P 518 46-A

ON-SITE SEWAGE DISPOSAL SYSTEM HOWARD COUNTY HEALTH DEPARTMENT BUREAU OF ENVIRONMENTAL HEALTH

ADDRESS: 12578 Hall Shop Road PROPERTY OWNER: Cynthia Hall

SITE INSPECTION SHEET

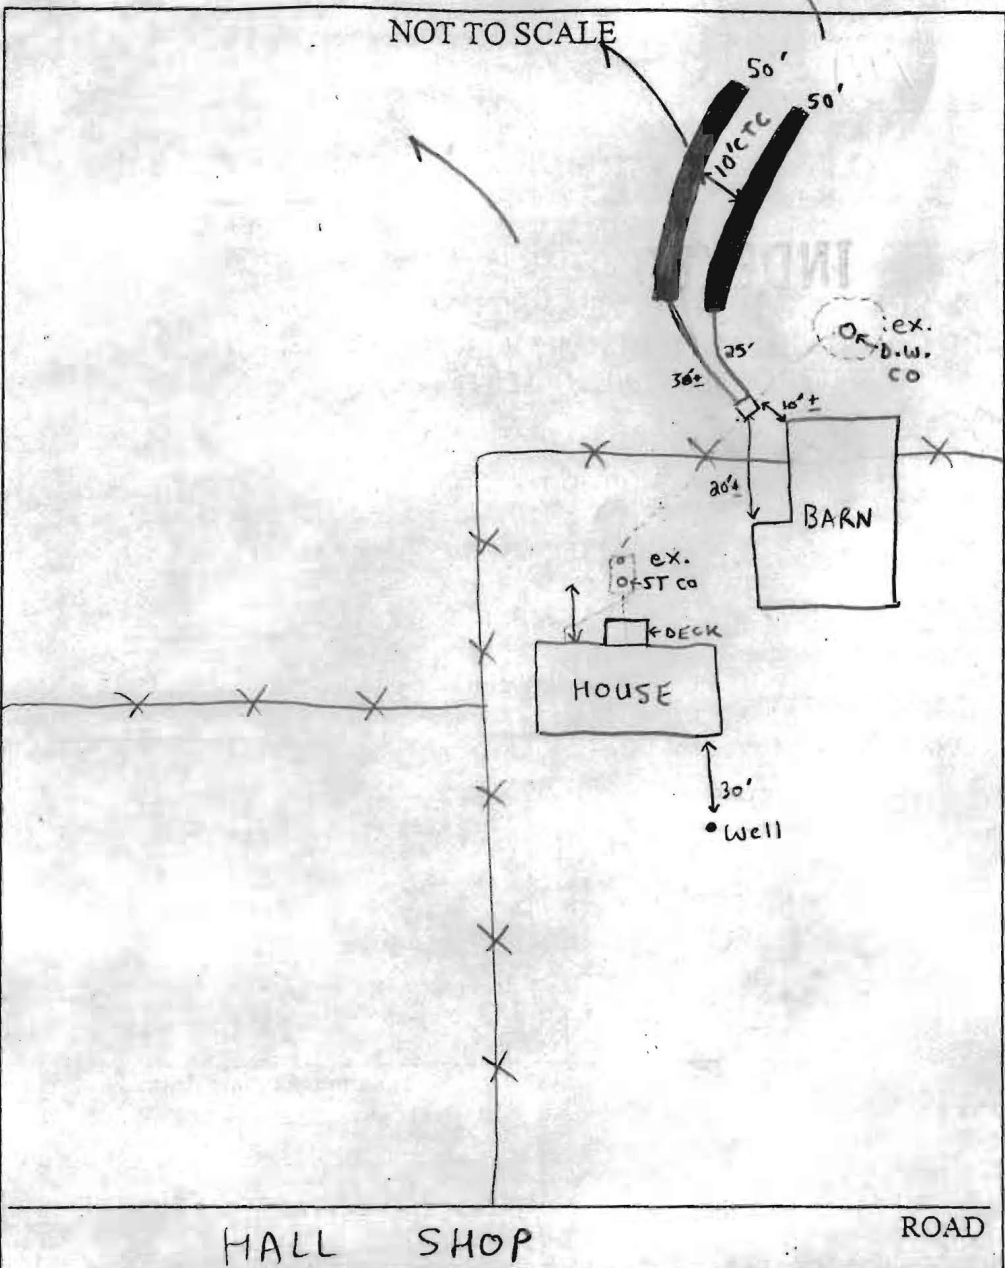
TRENCHES:	Trench to be 2 feet wide. Inlet 3 feet below original grade. Bottom maximum depth 7 feet below original grade. Effective area begins at 3 feet below original grade. 4 feet of stone below distribution pipe.
LOCATION:	Install (2) 50' trenches on contour D.B. in line to D.W. w/ speed leveler up for D.W.
PURPOSE:	Septic system has failed. Call for inspection when ground is opened so sanitarian can recommend repair. Start trenches 50' off fence

PRE-CONSTRUCTION 5/1/03 - DUG PERC HOLE IN LOCATION (A) & (B) SEE PERC TEST SHEET, INSTALL AS DISCUSSED - (SO) SRK

INSTALLATION 5/13/03 - OK TO COVER ALL WORK - (SRK)

LOCATION DIAGRAM

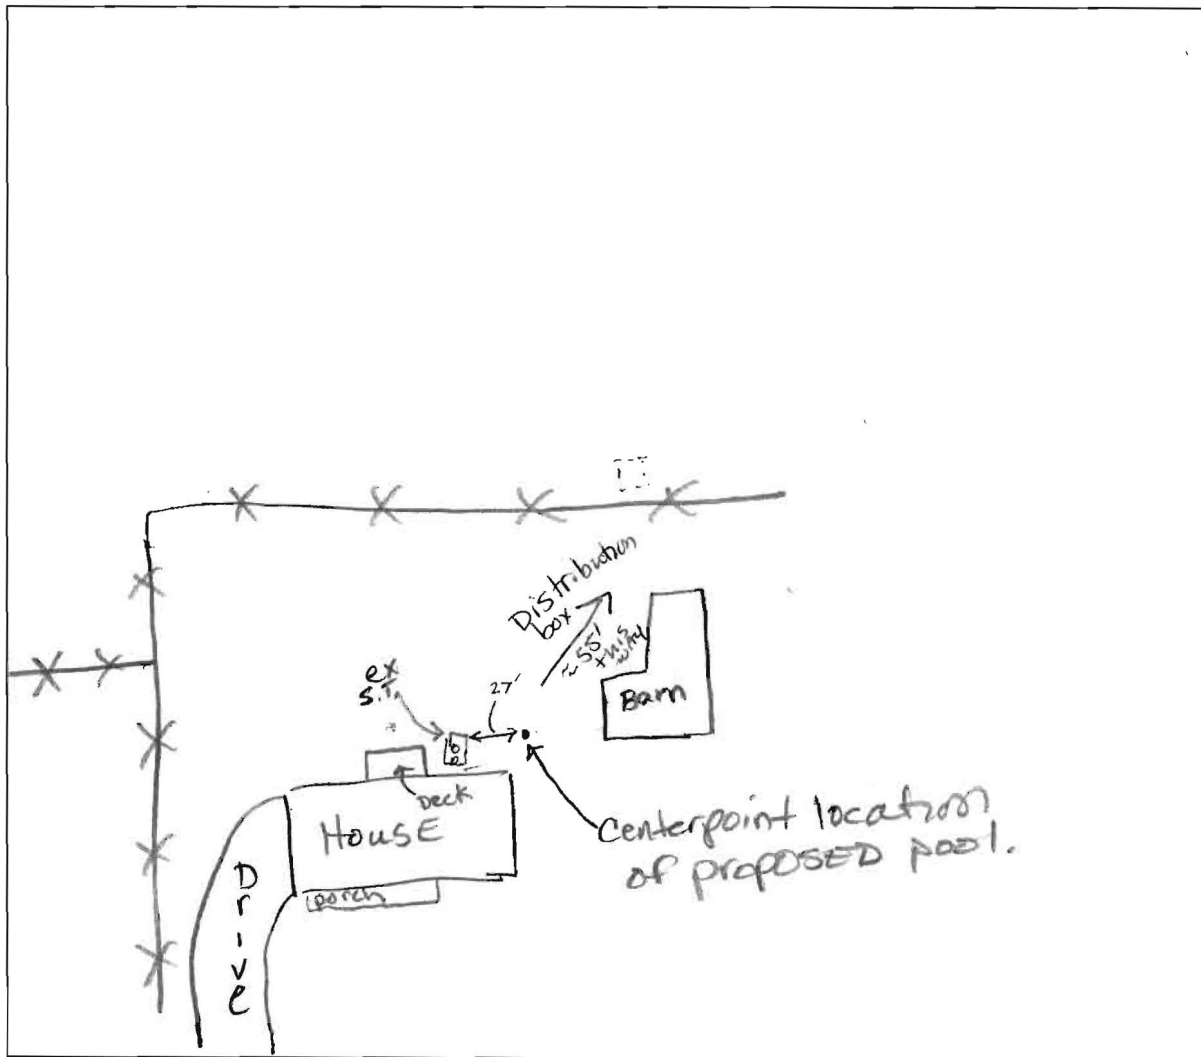
PROPOSAL: 5/30/03 BP 00142147 Locate septic tank
from proposed above-ground pool

COMMENTS: 5/30/03 Pool 24' in diameter; edge of
pool 13' away from septic tank & > 20' to
distribution box - signed BP. (KN)
